ABP-322638-25

Kishoge Part X

Response to
Submissions.

Proposed mixed use residential-led development of 1,252no. dwellings, childcare, employment, retail and community uses, and associated site development works, at Kishoge Development Area, Clonburris SDZ, in the townlands of Kishoge, Esker South, Grange and Balgaddy, Clonburris, County Dublin.

Figure 1: Extract from the submitted Architectural Design Statement, prepared by O'Mahony Pike Architects

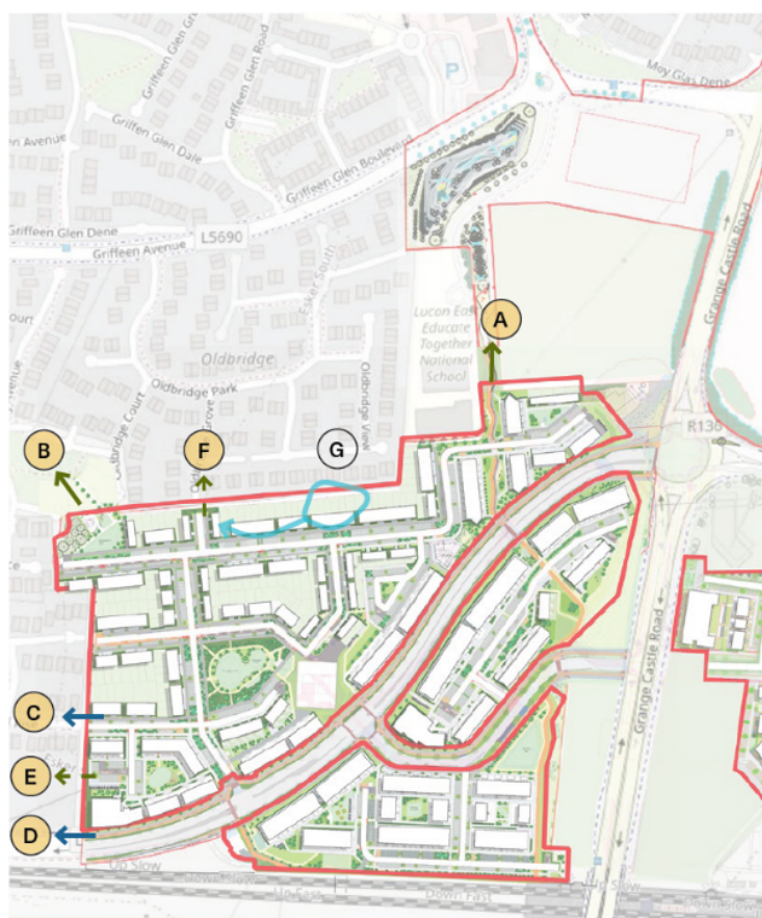
Concerns have been raised regarding the proposed permeability links within **Sites 3 and 5**. In the submission made by BPS Planning & Development Consultants on behalf of Tullyhall Residents Association, particular concern was raised in respect of the vehicular, pedestrian and cycle access proposed from Tullyhall through to **Site 3**.

Cllr. Liona O’Toole further opposes the permeability links that *“alter the character and safety if estates like Foxborough, Tullyhall, Rossberry and Oldbridge”*. Cllr. Madeleine Johansson, Eoin Ó Broin TD, Mark Ward TD, Derren Ó Bradaigh (Lucan Area Representative), Paul Gogarty TD and Cllr. Helen Farrell further echo this sentiment.

As detailed on page 41 of the Architectural Design Statement, prepared by O’Mahony Pike Architects, the Site 3 proposal has two physical connections into adjoining estates: one vehicular, cycling and pedestrian connection via Tullyhall Rise (C), and one cycling and pedestrian connection via Rossberry Park (B). Potential future pedestrian and cycling connections are indicated at Oldbridge Grove (F) and Tullyhall Drive (E), they are facilitated for future use, but not currently proposed part of this application.

The SDZ Planning Scheme indicates connections at Tullyhall Rise (C), Tullyhall Crescent, Rossberry Terrace and Rossberry Park (B). As noted in the detail design consideration on page 19 of the

Architectural Design Statement, only Tullyhall Rise and Rossberry Park can be delivered due to private ownership issues at the adjoining Cul-de-sacs.

A Stage 1 Road Safety Audit was provided in Appendix D of the Site 3 - Infrastructure Design Report. It did not identify any road safety issues with the intimate street connection to Tullyhall Rise at location C.

The applicant has maintained a vehicular connection to Tullyhall Rise, as in the Planning Application Reg. Ref. SDZ22A/0001 & SDZ23A/0033 submitted by ESB Telecoms Ltd, a Right of Way is shown on Site Location Maps connecting through to Tullyhall Rise.

The proposed intimate street connection to Tullyhall Rise is consistent with the SDZ Planning Scheme. If deemed necessary, a hammerhead cul-de-sac could also be provided and has been tested to be feasible from a technical point of view.

Figure 2: Inclusivity and Access Diagram from MDO Architectural Design Statement.

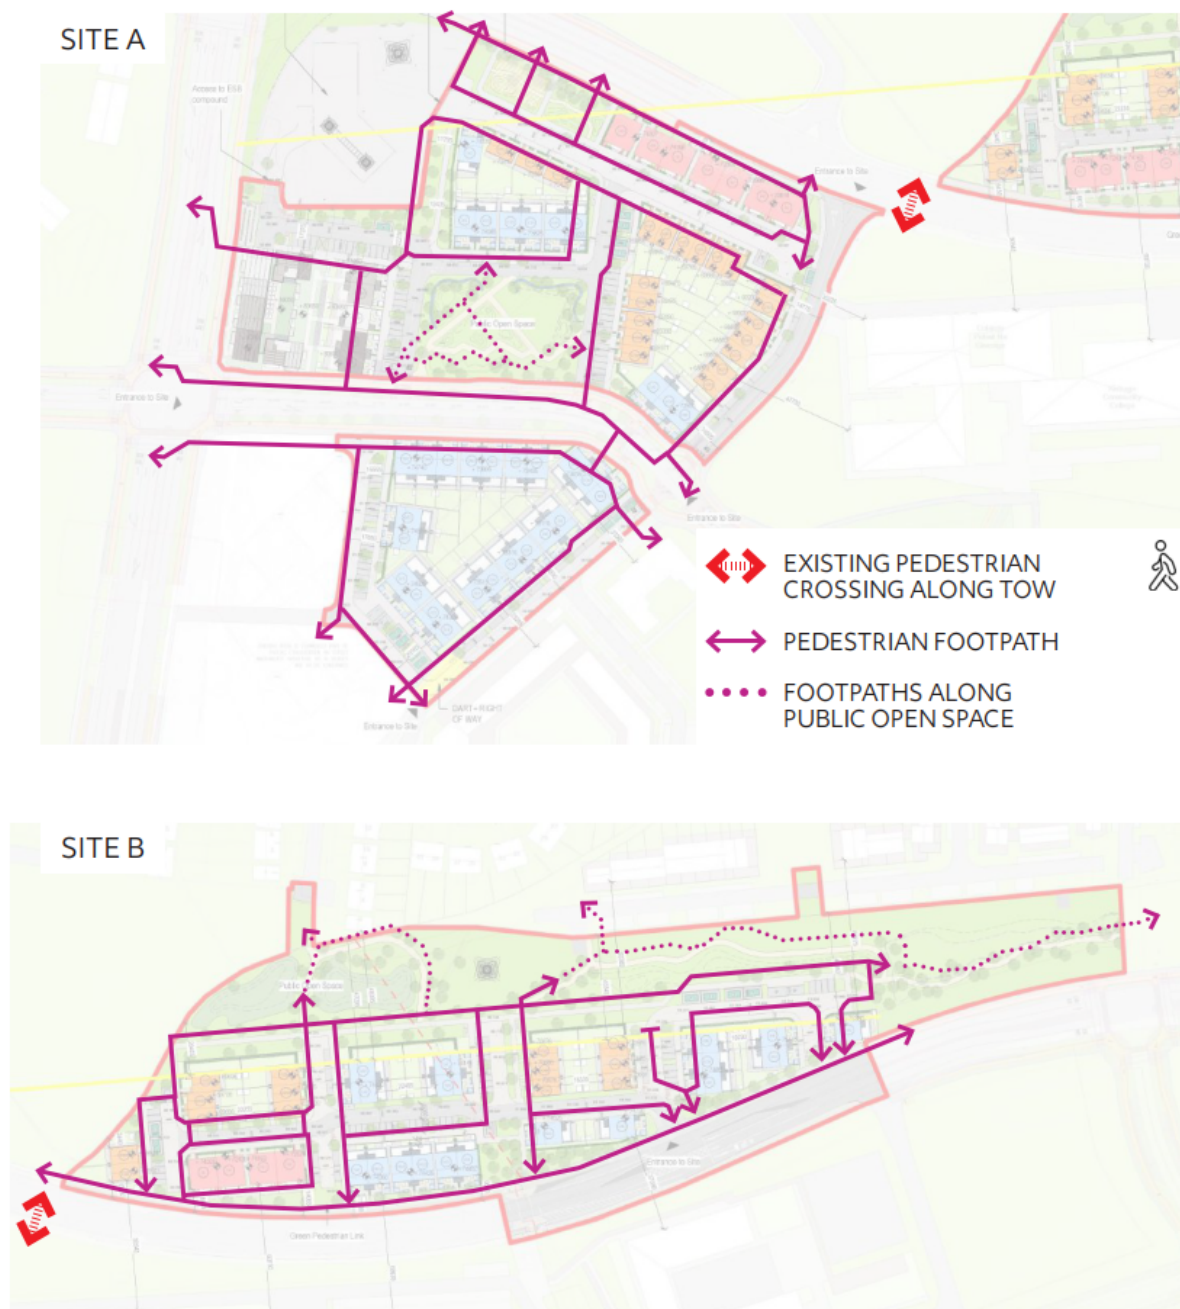
Foxborough Maintenance Association consider that the proposed pedestrian connection from Foxborough Court to **Site 5** is *“unnecessary and obtrusive and will result in negative impacts on residents”*.

During the **Site 5** design process, South Dublin County Council has taken into account the views of Foxborough residents regarding the proposed local street connection outlined in the SDZ (see p.29 of the MDO KSG-5 Architectural Design Statement). The original plan for a vehicular street connection between the development and Foxborough was reconsidered to a green corridor and pedestrian link. This revised connection will not only improve access to Griffen Community College but also enhance wider pedestrian and cycle networks, supporting sustainable travel and promoting stronger integration with the existing urban fabric.

Figure 3: Extract of Site 4 Proposed Site Layout Plan: KSG4-DTA-00-SP-DR-A-1000

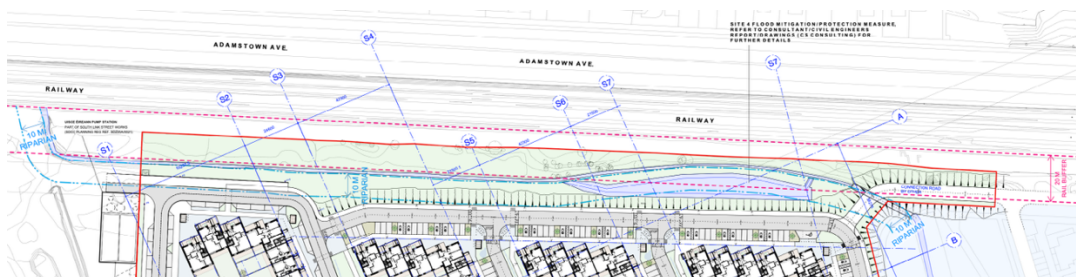
In the submission made by Iarnród Éireann it is highlighted that the proposed development is in close proximity to the DART+ South West Project. It is further noted that a “*preliminary review of the submitted boundary for the proposed development suggests there may be overlaps or conflicts with these designated lands*”.

The application red-line boundary aligns with the surveyed fence line located to the south of the railway within **Site 4**. This existing fence is nominally 7m south of the railway line. Property plans and boundary sections can be provided to Iarnród Éireann to support coordination, although the Site 4 team has identified no boundary conflicts. In addition, a minimum 20-metre railway buffer zone (designated no-build area), is maintained from the southern edge of the railway line within Site 4.

Figure 4: Extract of Site 5 Site Layout Drawing No. KSG5-MDO-XX-SP-DR-A-05001, prepared by McCauley Daye O’Connell Architects identifying the DART+ Right of Way.

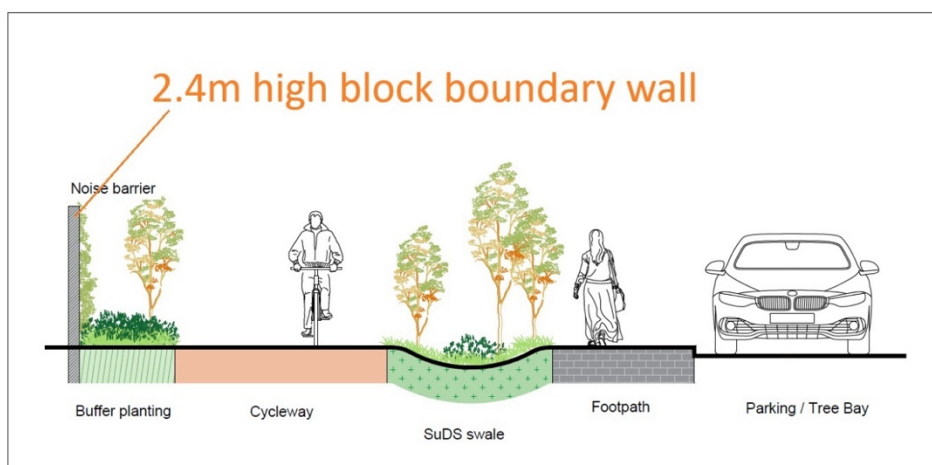
Iarnród Éireann further identify that C.I.É owns a section of Lynch’s Lane and request that the access route at the lane is maintained and kept clear at all times.

The section of Lynch’s Lane noted in the observation has been excluded from the Applicant’s blue-line boundary. Refer to drawings KSG-OMP-01-00-DR-A-1010 : Site Location Map Combined, and KSG-OMP-01-00-DR-A-1014, prepared by O’Mahony Pike Architects. As required by Iarnród Éireann, access via Lynch’s Lane will be preserved as part of the proposed development. Refer to **Site 5** drawing KSG5-MDO-XX-SP-DR-A-05001, prepared by McCauley Daye O’Connell Architects.

Figure 6: Extract from the submitted Preliminary Construction Environmental Management Plan, prepared by DBFL Consulting Engineers Indicative Phasing Plan with Zone 3D impacted by temporary lands acquisition highlighted.

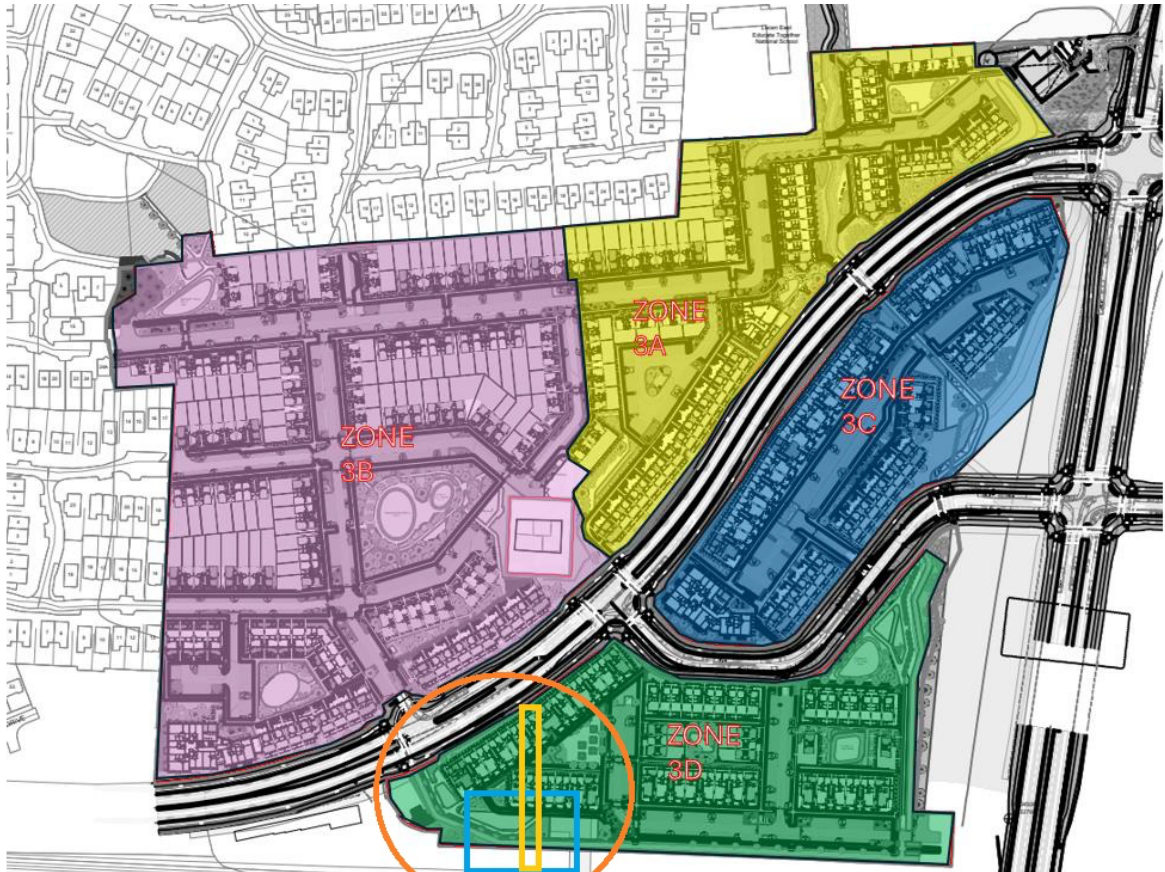
Iarnród Éireann raise concerns with location of the proposed buildings on top of its temporary compound for the DART+ South West works and is proximate to its proposed cable easements.

We would highlight that the proposed layout is compliant with the Clonburris Planning Scheme at this location for the delivery of housing. We do however note the conflict between the Railway Order

and the SDZ and have endeavored to comply with the SDZ whilst meeting Iarnród Éireanns technical requirements.

Regarding the lands identified for temporary acquisition on Site 3 for the delivery of Dart + SW, where a temporary compound is indicated, this area is in phase 3D of Figure 2.1 of the Applicant’s Preliminary Construction & Environmental Management Plan, prepared by DBFL Consulting Engineers. This is intended to be the last phase of the construction phasing for Site 3. It will be constructed after the DART+ infrastructure has been delivered and the DART+ temporary compound is no longer in place.
